UNITED STATES PATENT AND TRADEMARK OFFICE

Office Action Summary	Application No. 10/628,063	Applicant(s) LAWSON, DOUGLAS K.	
	Examiner Erica E Cadugan	Art Unit 3722

DETAILED ACTION

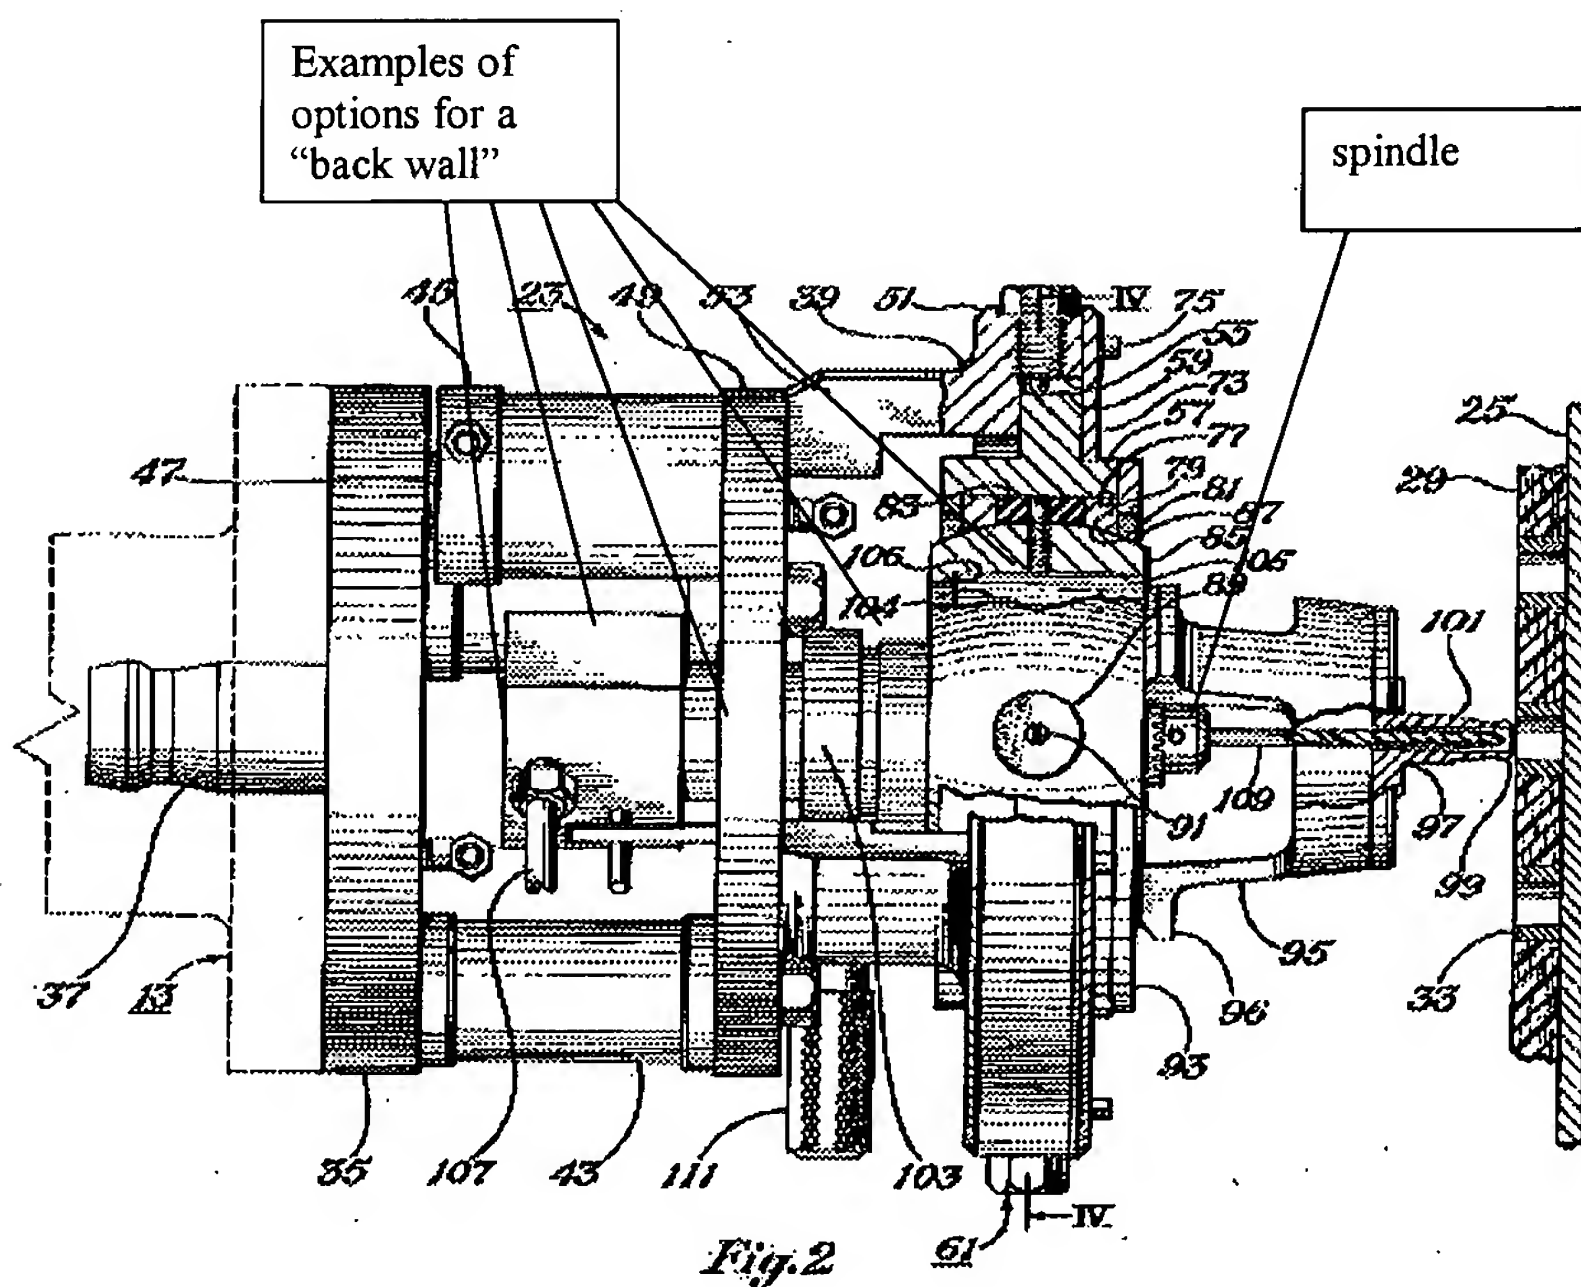
Hailey teaches a robotic drilling device. It is noted that there is nothing preventing an end user from using a drill to “deburr” a hole, for example. Hailey’s device includes a drill 103 having a drill motor that is “driven by air supplied to a manifold through conduits 107” (col. 4, lines 26-27. Note that the motor is located within a “housing”, such as being located at least within the perimeter of members 51 and 53, see Figure 2.

Also, as illustrated in the above reproduction of Figure 2, there are several walls or surfaces of Hailey’s device that can be considered a “back wall”, forming a “back portion” of the device or motor as set forth in claim 14, for example, particularly since they are walls or portions that are located “away” from the vicinity of the “front” portion where the cutter is located.

At the right (as viewed in Figure 2) end of the drill 103 is mounted a cutter 109, and thus the right end of the drill (as shown above) can be considered a spindle, and the vicinity in which the cutter 109 is attached to the spindle is considered the “front” end of the device as claimed.

Note also that ring 79 has a concave spherical (see Figures 2 and 4, also col. 3, lines 33-66, and especially col. 3, lines 59-63, for example) surface 81, constituting a bearing surface, and thus ring 79 constitutes the claimed “pivot bearing”. Spherical member 85 has a convex surface that mates in sliding contact with the surface 81 (see Figures 2, 4, and col. 3, lines 33-66, for example). Note that member or “pivot bearing” 79 is located “adjacent” various ones of the aforescribed “back walls” and is thus considered “adjacent” to the “back portion” of the motor. Also note that member 85 extends “from” a circumferential wall that can be considered a “back wall” or a part of a “back portion” as described previously, and thus member 85 constitutes the claimed “connector”.

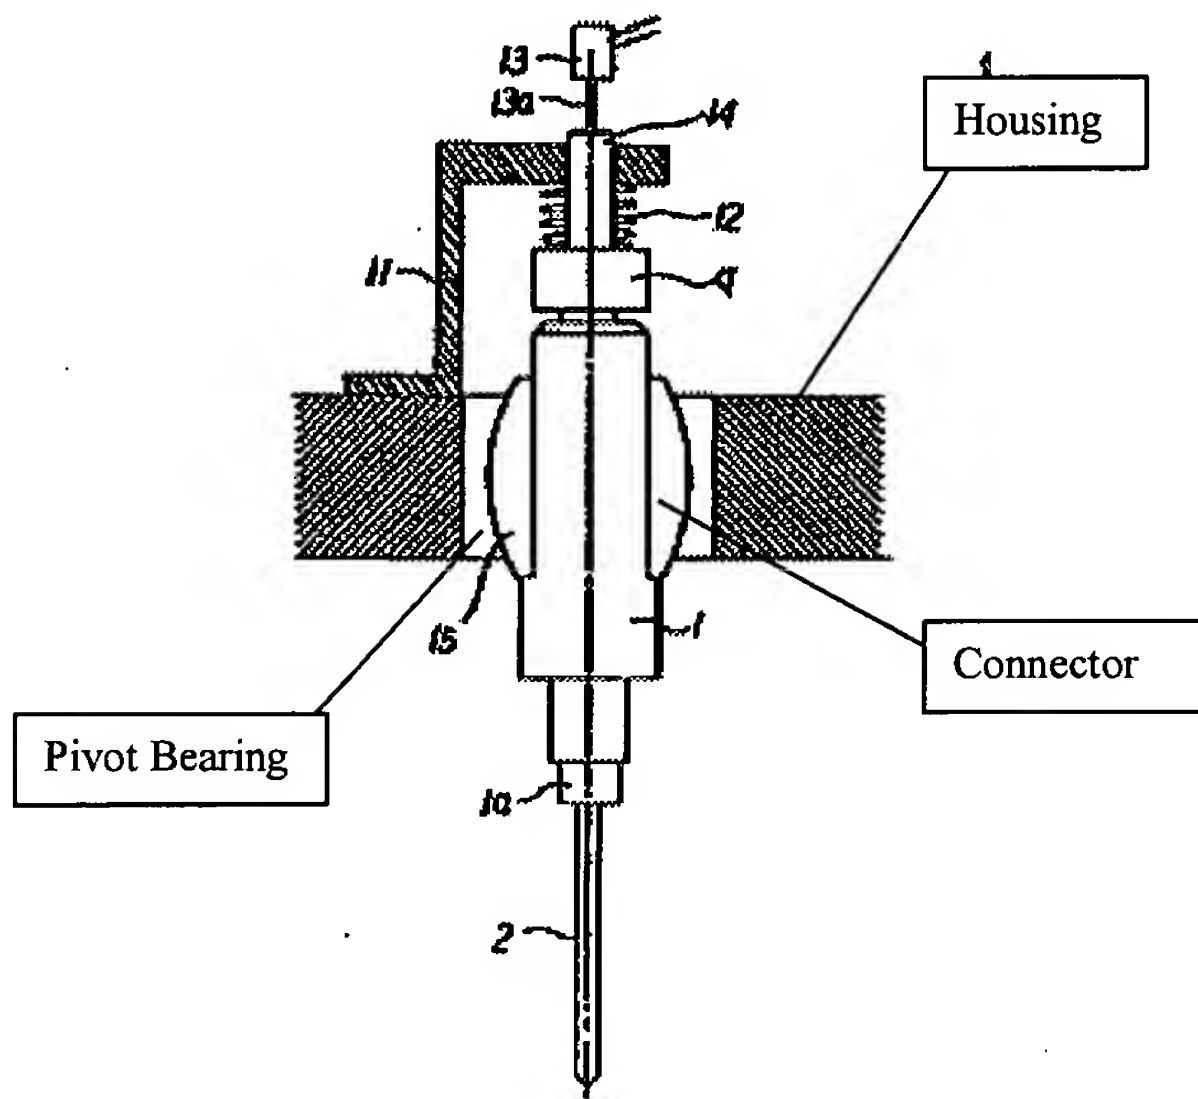
Note that '811 teaches a deburring device (see English abstract) having a motor 1 (Examiner orally consulted a Japanese translator who indicated that the first full paragraph in the upper left portion of the left column on page 70 teaches that element 1 is a motor whose driving source is either electric or fluid) mounted within a housing (as indicated in the reproduction of Figure 5 below).

Note that the “pivot bearing” (shown above) is located “adjacent” the “back portion” of the motor, as broadly claimed. Further note that ‘811 teaches the connector extending between the motor 1 and the pivot bearing as shown above.

Regarding claim 15, note, for example, that the outer circumferential wall of the motor where the pivot bearing and connector 15 are located can be considered the “back wall” as claimed, since, for example, that is a wall that is located at the “back” of the motor with respect to where the tool 2 is located. Also note that the “pivot bearing” has an opening in which the “connector” is located (see Figure 5).

Re claim 28, note that the circumferential wall of the motor 1 about which the pivot bearing and connector extend can be considered a “back wall” as claimed in claim 28, since, for example, it is a wall located “behind” the planar “front” or top (as viewed in Figure 5) wall thereof.
